Geotechnical Exploration, Inc.

Job No. 16-11251

Subject: **Response to City of San Diego Cycle Review Comments LDR-Geology: Project No. 508125, Cycle Issue 11**
Proposed Foxhill Residence
7007 Country Club Drive
La Jolla, California

Project	FOXHILL ESTATES			SECTION B-B'
Analysis Description	SURFICIAL SLOPE STABILITY			
Drawn By	R.A.C.	Scale	1:400	Company
Date	3/5/2020, 9:23:41 AM			G.E.I.
		File Name	JOB NO. 16-11251_S(B)_03.slim

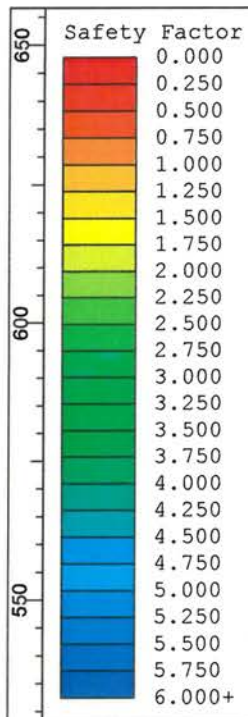
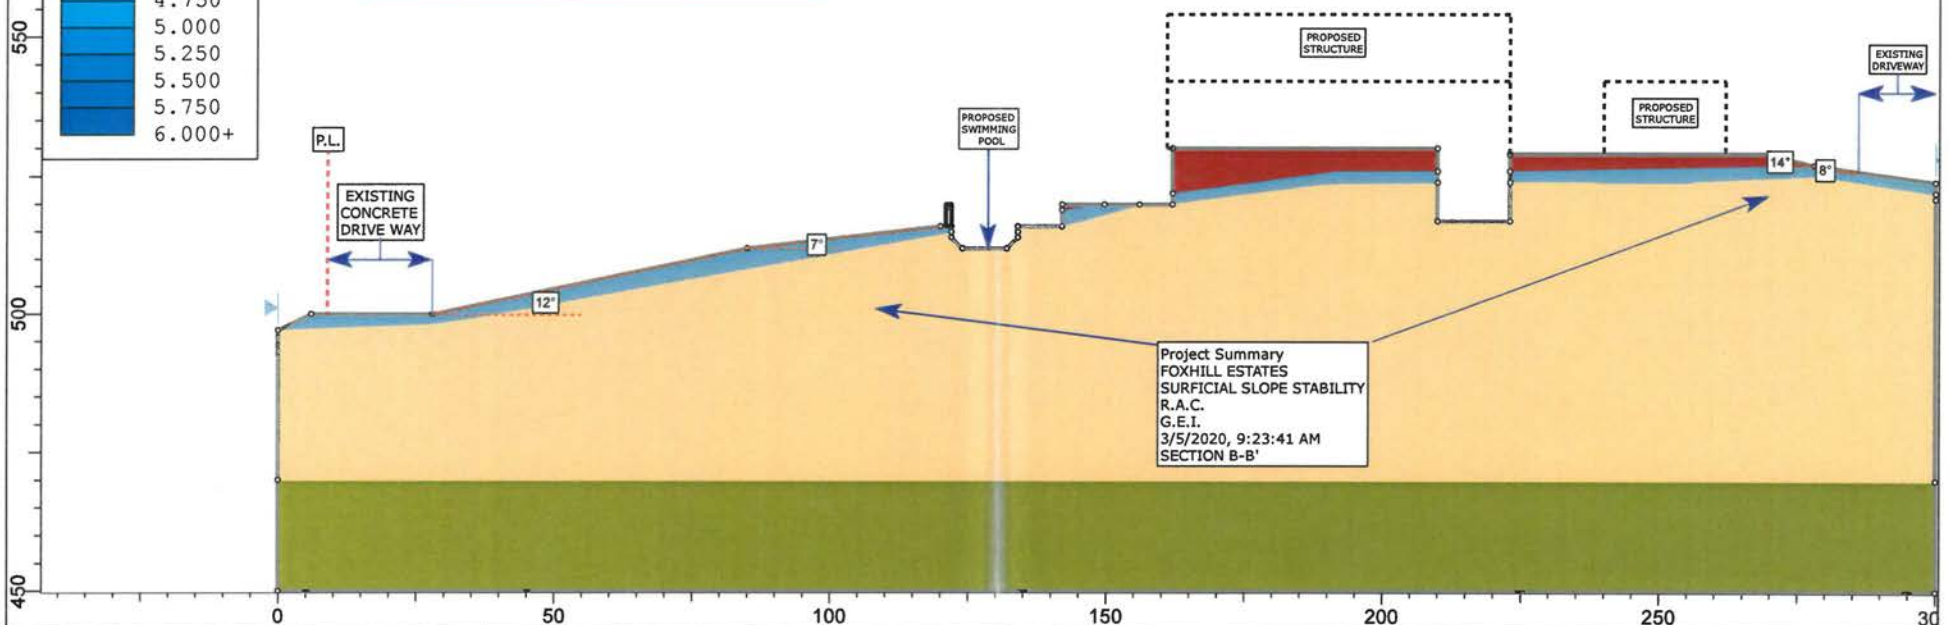
Issue No. 7: *The project's geotechnical consultant must provide a professional opinion that the site will have a factor-of-safety of 1.5 or greater, for both gross and surficial, following project completion. (Outstanding Issue from Cycle 2)*

The surficial slope stability calculations were performed on the slope face using a geotechnical accepted equation for infinite slopes with a saturated upper layer. The calculations were performed by assuming that the upper 5 feet of those soils were saturated. Based on the current existing slope, the calculations yielded the Factor of Safety against shear failure above 1.50 for a sliding block 5 feet high against the soil shear strength frictional and cohesion strength opposing the driving force. The slope is considered adequate against surficial failures.

The Factor of Safety values are **ABOVE** 1.50 and are adequate.
